NOTICE OF DECISION

1951 Schurman – Parking Modification

Land Use Application Nos.:	WLD-2023-008 (Site Plan Review – Type 1)
Applicant:	PLS Engineering
Property Owner:	DT Realty LLC Mark Dawkins 610 NW 16 th Cir Ridgefield, WA, 98642
Site Location:	1951 Schurman Way Woodland, WA 98674
Parcel & Size:	507870102, 3.06 Acres
Zoning Designation:	Light Industrial, I-1
Date Application Received:	October 25 th , 2023
Notice of Decision Issued:	November 27 th , 2023
DRC Decision:	Approve with Conditions

Applicant proposes changes to the parking plan for the warehouse/office project approved under SPR-22-004.

Site Plan For
Dawkins Warehouse
A Site Located in the City of Woodland, Washington

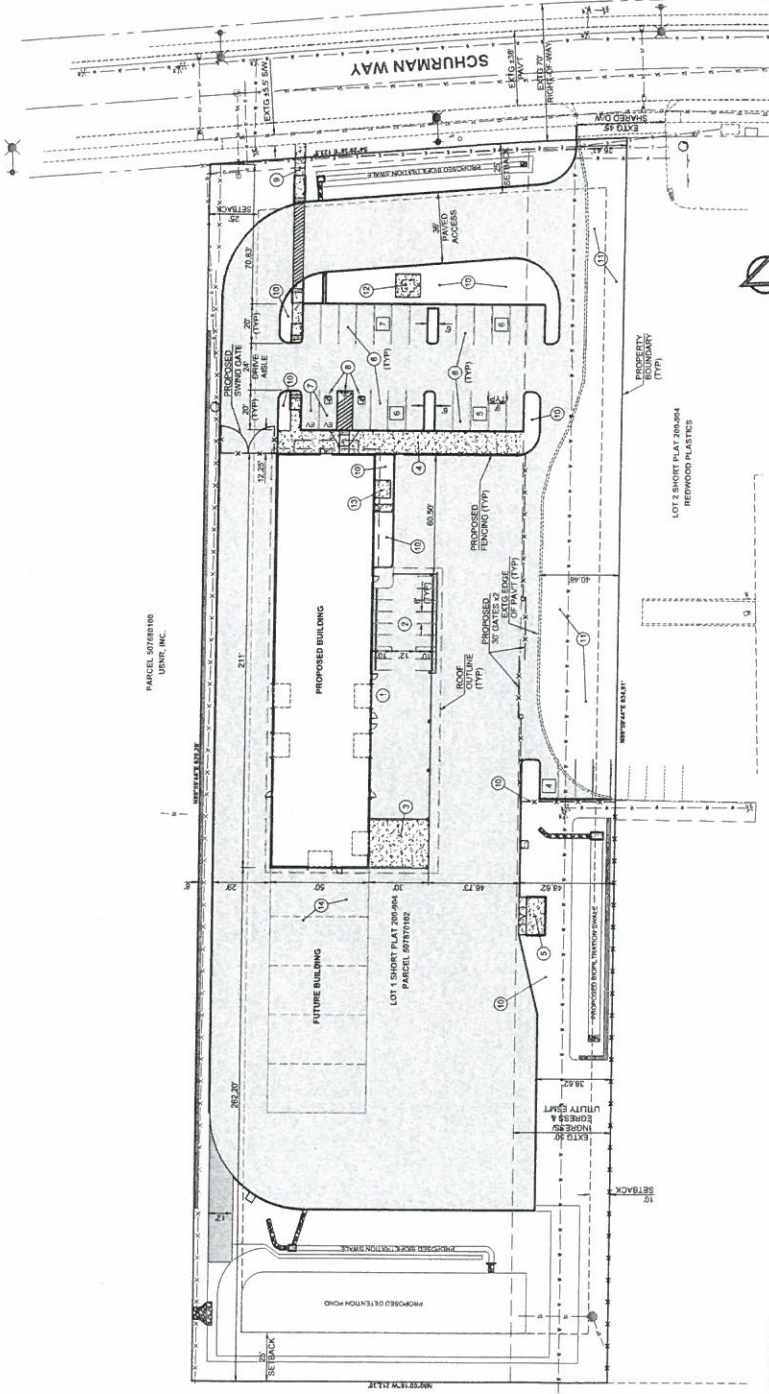
Finding 10: On the provided revised site plan parking has been located to the front and side of the proposed building. Parking area is appropriately landscaped with proposed landscaping that meets the requirements within WMC Chapter 17.44.

Finding 15: There are a total of 25 proposed parking spaces identified on the revised site plan, including one regular EV parking space, one EV ADA handicapped space, and one typical ADA handicapped parking space. This exceeds the required number of parking spaces based on floor area, however is not consistent with WAC 51-50-0429 and/or IBC (One additional EV Station will be required). This condition from SPR-22-004 is still applicable.

Finding 29: The proposed parking lot consists of 25 parking spaces and 10 trees, which exceeds the 6 trees required to meet this standard. Landscaping islands are indicated that generally comply with WMC 17.44.136 (F)(2) with trees flanking the parking islands and in between rows of parking.

Finding 37: The site plan shows two ADA parking spaces. These meets building code requirements.

Finding 38: Per Washington State Code 51-50-0429 Section 429, electric vehicle charging infrastructure must be provided for at least ten percent of provided parking spaces. For the proposed 25 parking spaces, this would require 3 EV spaces be available while two are listed on provided site plan. One EV charging space must be an ADA-compatible space, one of which is indicated on provided preliminary site plan. A condition has been added that one more EV space must be added to final engineering. *(See condition 10 below)*

10. One additional EV charging parking space must be indicated on final engineering plans and installed prior to receiving their certificate of occupancy consistent with WAC 51-50-0429, and installed alongside construction of the proposed parking area.
11. Applicant is responsible for submitting a revised site plan alongside proposed final civil engineering plan(s) at Civil Review. Civil review packet should include all documents required to document the applicant's compliance with listed conditions of approval, as well as all revised engineering plans reflecting provided engineering comments. The civil review application can be found: <https://www.ci.woodland.wa.us/planning/page/civil-review-submission>.
